ACT Planning &
Land Authority

Macgregor West Concept Plan

Addenda for Concept Plan

Figure 3 Macgregor West Indicative Subdivision Plan

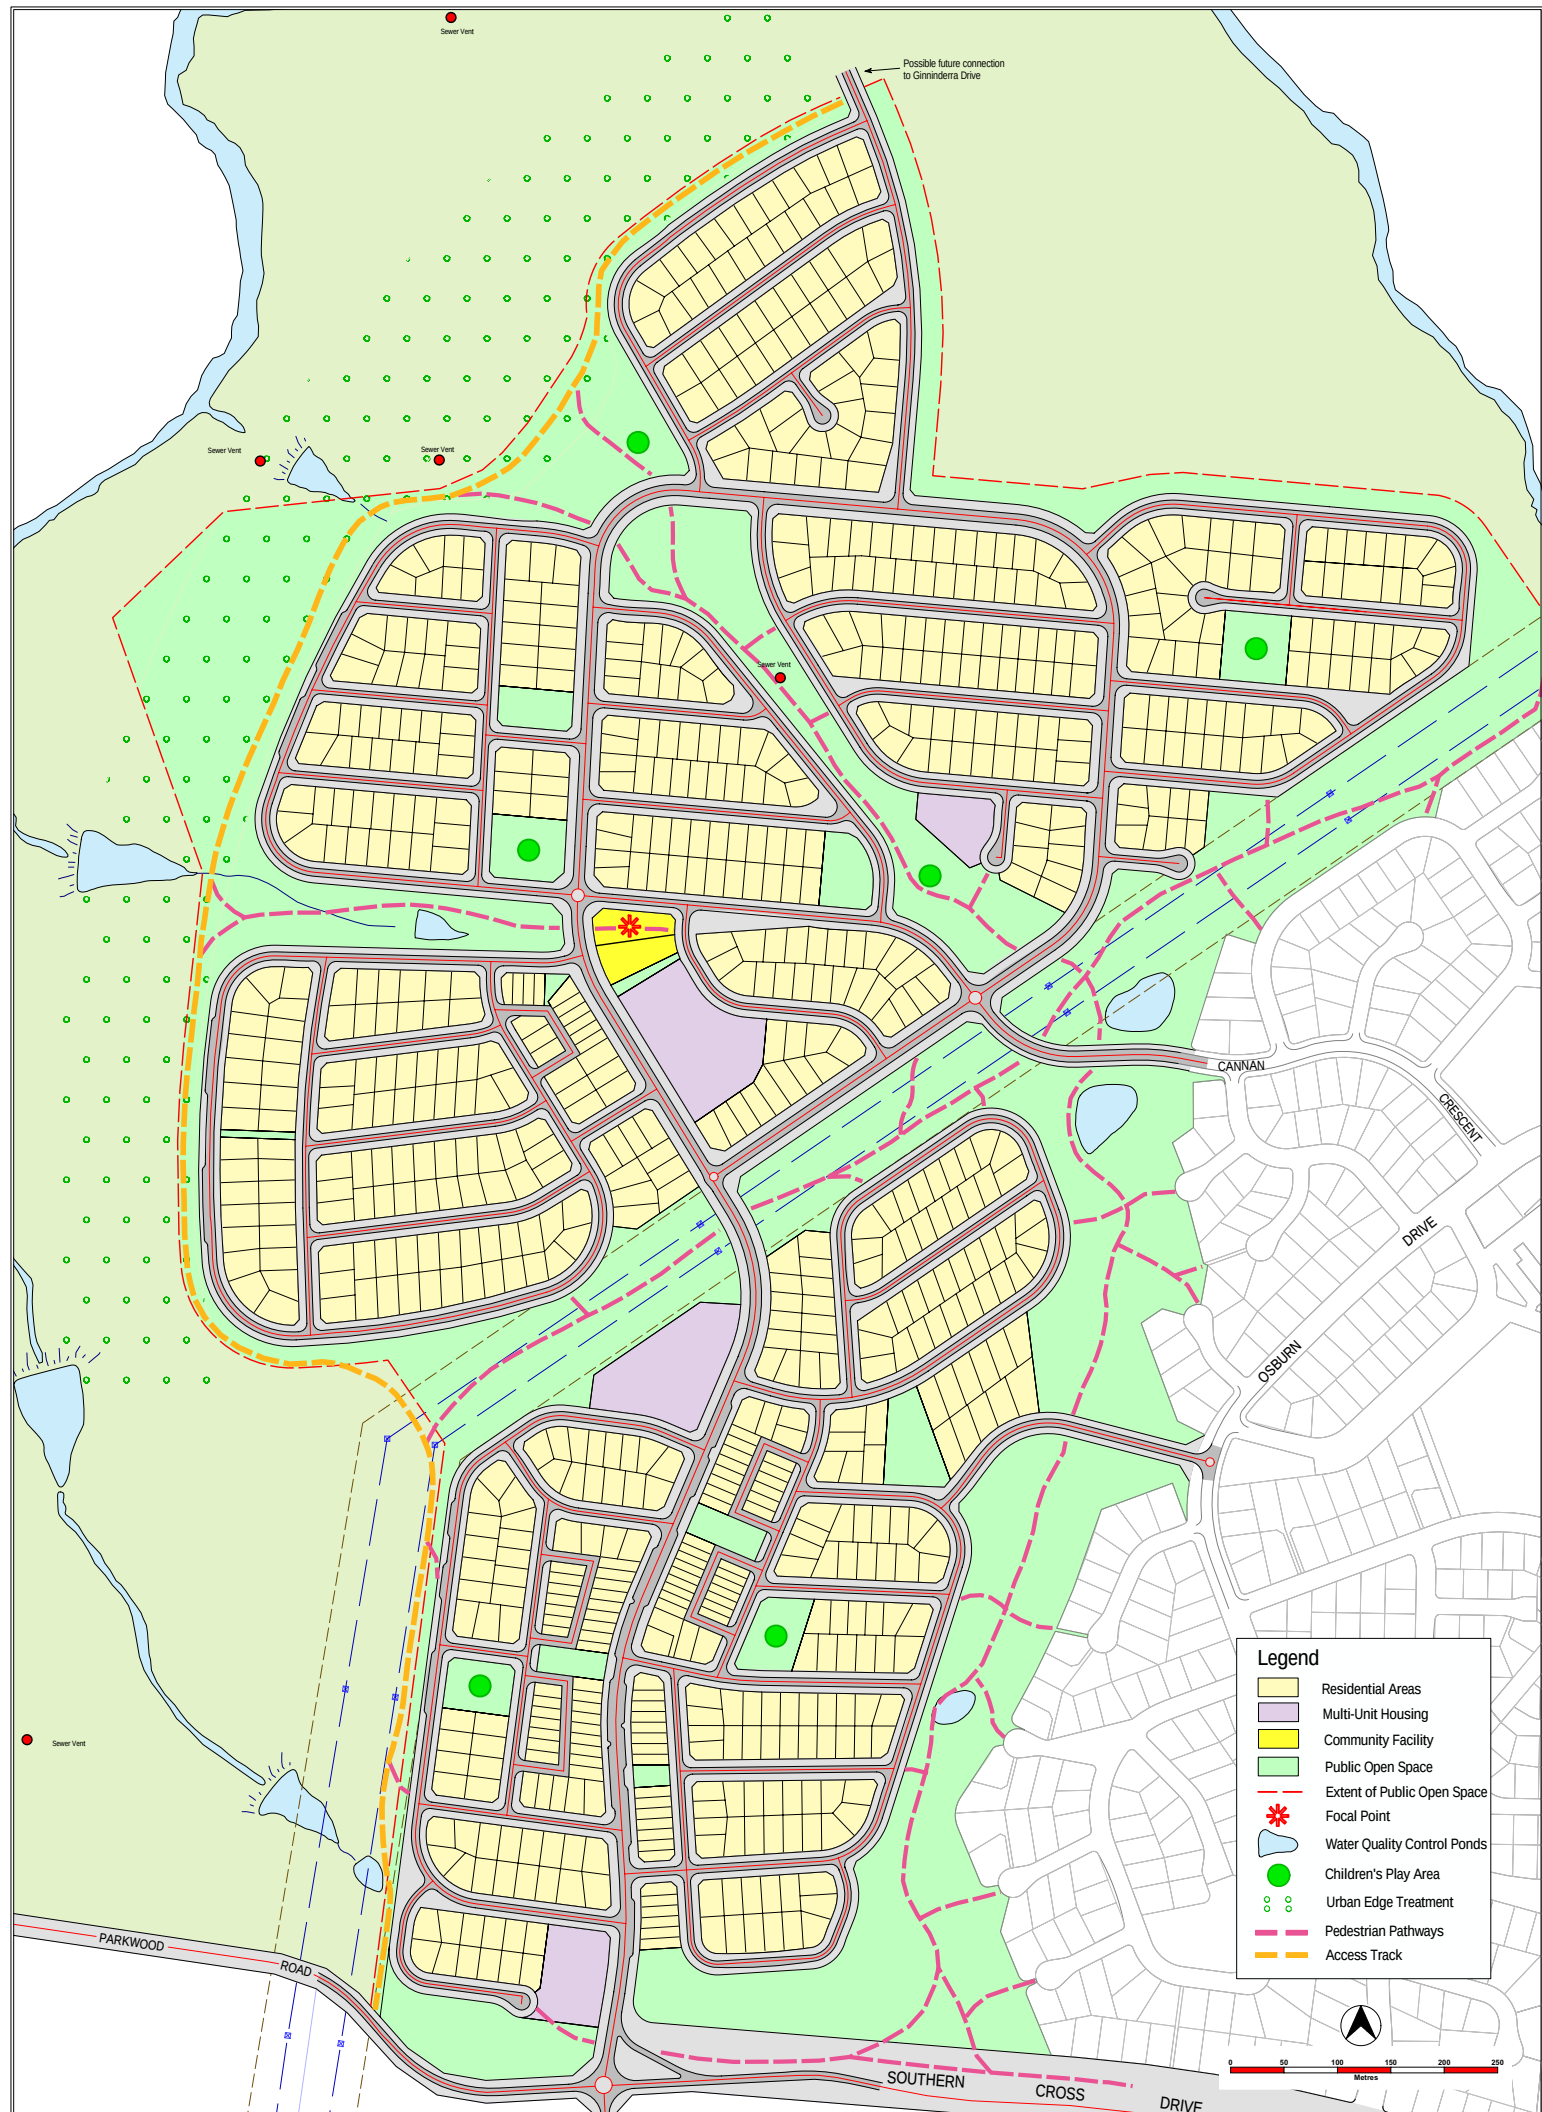
Please note that this Concept Plan Report has been amended in relation to the Territory Plan Land Use Policy for the Neighbourhood Focal Point and the associated community facility site from a Residential Land Use Policy to a Community Facility Land Use Policy.

The Neighbourhood Focal Point and the associated community facility site is referred to in Sections 3.5 and 5.11 and indicated in the Concept Plan, Indicative Subdivision Plan and the Important Planning Requirements Plan.

Following a further review, the land take for the combined site has been reduced from 8,000m² to 4,000m².
